Access Compliance Report

Public Rights-of-Way

(Curb Ramps)

Intersection ID: 5468	Main Street: N_TRYON_ST	Cross Street: J_W_CLAY_BV	Location: W
ADA ID: 1F07F18D23BF	Ramp Type: Perp	Initial Pass/Fail: Fail	Overall Compliance: No
Severity Score: 12.5			
Codes/Mitigation Info/Possible Solution		Field Measurements/Component Compliance

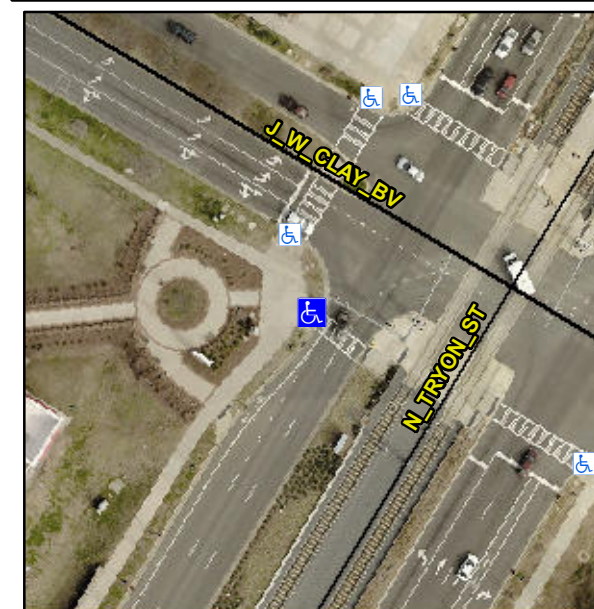
R304.2.2

Compliance	Description	Data	Compliance	Description	Data
N/A	Ramp Length (in)	75.0	No	Ramp Slope (%)	8.7
Yes	Ramp Width (in)	48.0	Yes	Ramp XSlope (%)	0.9
N/A	Flare Type LT	N/A	N/A	Flare Type RT	N/A
N/A	Flare Slope LT (%)	N/A	N/A	Flare Slope RT (%)	N/A
N/A	Flare Traversable LT?	N/A	N/A	Flare Traversable RT?	N/A
N/A	Landing Length (in)	N/A	N/A	DWS Provided?	N/A
N/A	Landing Width (in)	N/A	N/A	DWS Contrast?	N/A
N/A	Landing Slope (%)	N/A	N/A	DWS Length (in)	N/A
N/A	Landing X Slope (%)	N/A	N/A	DWS Full Width?	N/A
N/A	Landing Curb? (Y/N)	N/A	N/A	DWS Offset (in)	N/A
N/A	Shared Landing?	N/A			
N/A	Gutter Ponding?	Yes	N/A	Gutter Slope (%)	N/A
N/A	Gutter Lip Ht (in)	N/A	N/A	Gutter X Slope (%)	N/A
N/A	Painted X Walk1?	No	N/A	Painted X Walk2?	N/A
	X Walk 1 Direction	To SE		X Walk 2 Direction	N/A
N/A	X Walk 1 Width (in)	N/A	N/A	X Walk 2 Width (in)	N/A
	X Walk 1 Slope (%)	2.3		X Walk 2 Slope (%)	N/A
	X Walk 1 X Slope (%)	0.9		X Walk 2 X Slope (%)	N/A

Remove & Replace Entire Ramp.
